'74 EXPO U.S. PAVILION

DESIGN REVIEW BOARD STEP 2 RECOMMENDATION MEETING WRITTEN PROJECT SUMMARY

Spokane Parks and Recreation

Submittal Date: 1.24.18

2C - SUSTAINABLE MEASURES

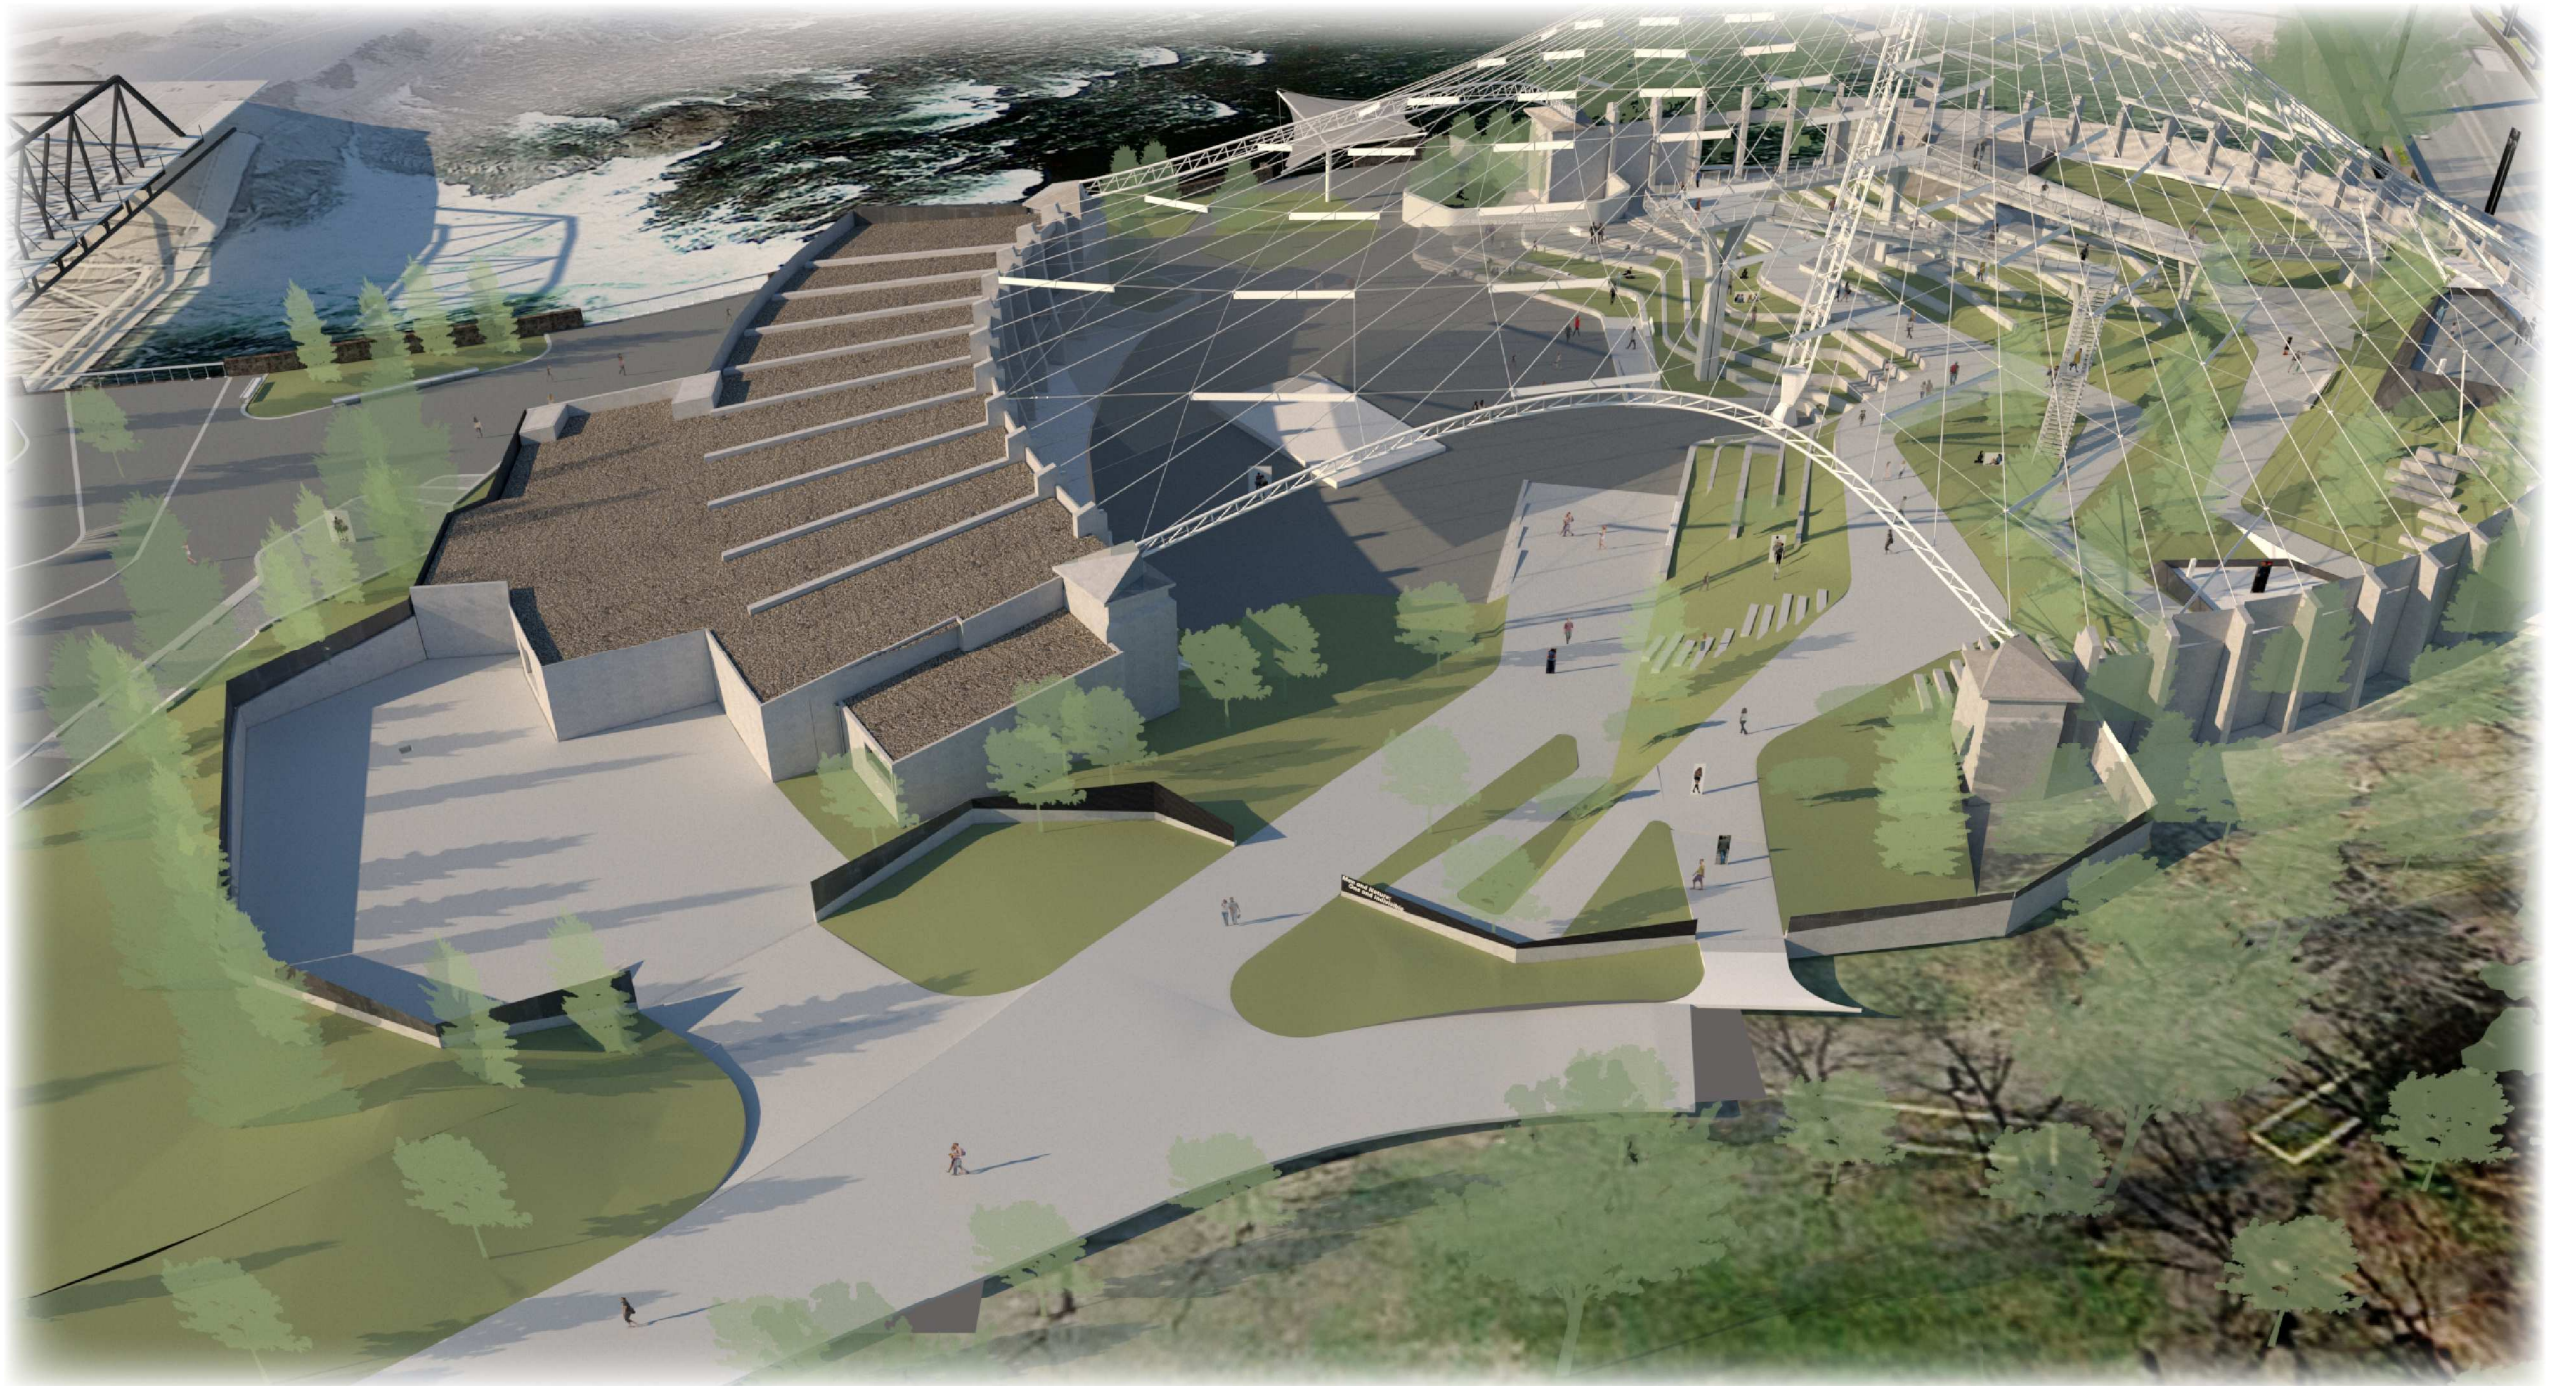
THE APPLICANT SHALL PUSH FOR SUSTAINABLE MEASURES WHERE APPROPRIATE IN RECOGNITION OF THE DOWNTOWN DESIGN GUIDELINES FOR SUSTAINABILITY AND IN CONSIDERATION OF THE HISTORIC SIGNIFICANCE OF THE ENVIRONMENT AND THE U.S. PAVILION.

The design team understands the historic significance of the first environmental theme world’s fair. In recognition of the ‘74 expo theme, the design team has pursued the following sustainable measures:

- > **Adaptive reuse**
 - › One of the most sustainable measures we can take is to reuse the existing building and structure. The design team has made a significant effort to utilize as much of the existing structure as possible while keeping the footprint to the minimum required by the program.

- > **Giving the land back to nature**
 - › The design proposes to remove a significant amount of impervious surface and replace it with pervious surfaces and/or plantings.

- > **Energy efficient building systems and thermal envelope**
 - › The project must meet the requirements of the Washington State Energy Code by incorporating energy efficient measures such as:

- » Tight and efficient thermal envelope incorporating new insulation on roof and continuous wall insulation where possible. The project will also incorporate energy efficient glazing systems.

- » High efficiency HVAC systems meeting the WSEC, including ventilation standards.
 - » Low energy consuming LED lighting fixtures.
- > **Water efficient landscaping**

- › Where possible, the proposed design will incorporate xeriscaping and native plants requiring little to no irrigation.

2D - SERVICE AREA

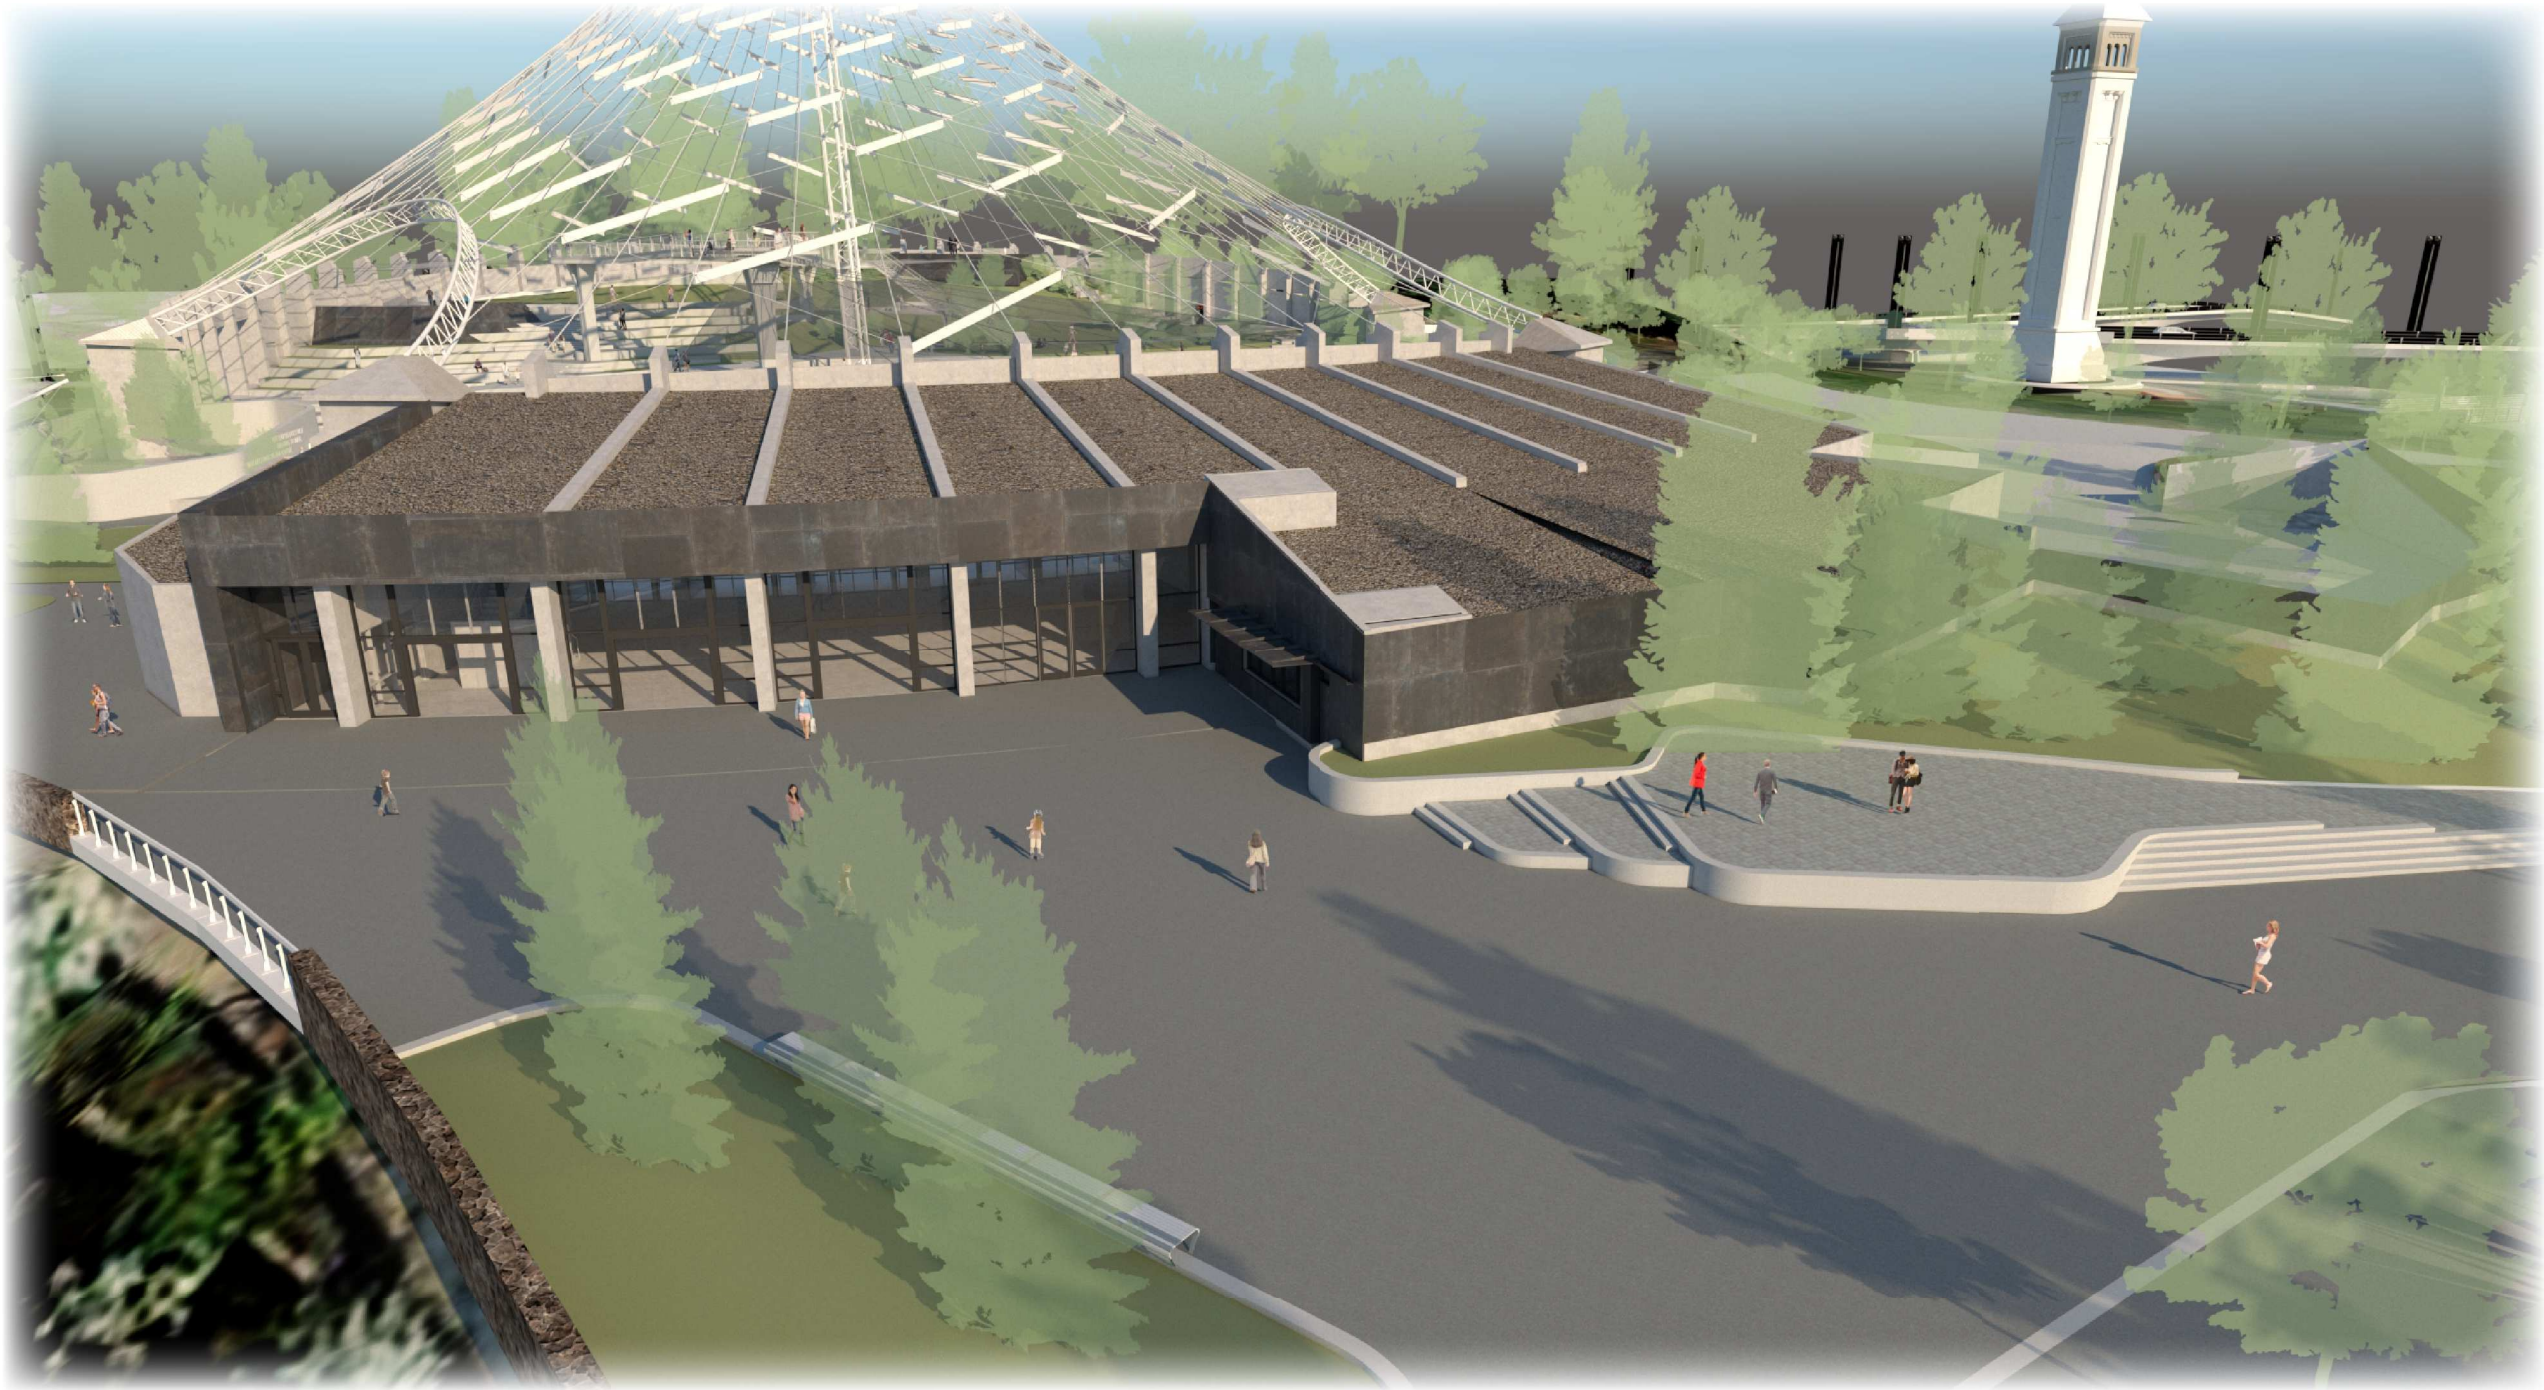
CONTINUE TO DEVELOP THE SERVICE AREA ON THE SOUTH SIDE OF THE SITE AND BE PREPARED TO ADDRESS HOW IT MEETS THE BLANK WALLS SCREENING REQUIREMENTS.

The design proposes to include a steel “ribbon.” The ribbon is a design element that ties much of the west and south architecture together. The ribbon is proposed to be made from raw steel plate, that has a natural patina and is then clear coated to maintain the desired aesthetic. A similar concept was used at the Loof carousel. Starting from the administration building northwest entry, the steel ribbon will be used as a wall cladding and as it continues south, it breaks from the wall to become a screen wall for the service yard. As it moves southeast, the steel ribbon dissolves and becomes more transparent as it changes to security fencing and gates.

In order to address the treatment of blank walls, the design is taking a wholistic, and restrained approach. As noted in the Step 1 submittal, the pavilion really has a unique design aesthetic that should be respected and does not necessarily meet the current municipal code requirements. The design team is striving to meet the current municipal code requirements while maintaining and respecting the existing pavilion structure. For example, the design team is proposing to create an inverted, ligthed, concrete “plinth” at the base of the west elevation. The design team may utilize CNC patterning on the steel ribbon in strategic locations for graphics and/or signage or as a homage to the pavilion history. Additionally, there will be a pattern to the layout of the steel sheets. There will be a modeled look to the wall cladding material and it will be naturally variegated. The steel ribbon will morph and change in opacity along its length to add visual interest. The west wall will be buffered by landscaping that is similar to the conservation area landscape located directly across the Howard Street Promenade.
